Product Name: LTE-A Cat 6 M.2 Module

Model Number: EM060K-GL

Hardware Version: R1.0

The new version of EM060K-GL share the same HW design with the certificated version, The main differences are the DUP and saw filter as follow:

1. There are some differences in the shielding frame of EM060K-GL original and new version.

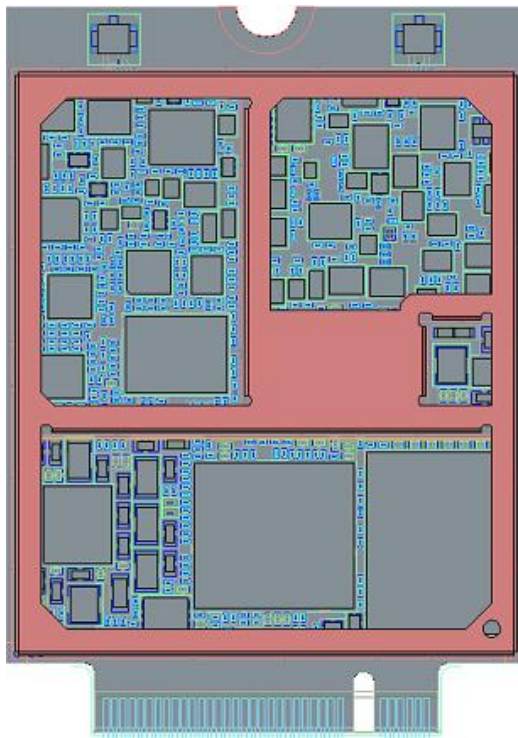
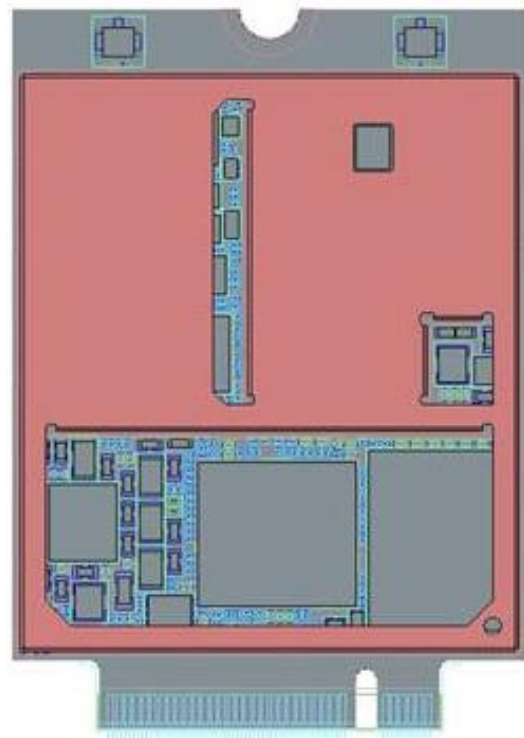
EM060K-GL shielding frame(Module original)

EM060K-GL shielding frame(new version)

Above changes won't impact the protocol and RF performance for original frequency bands.
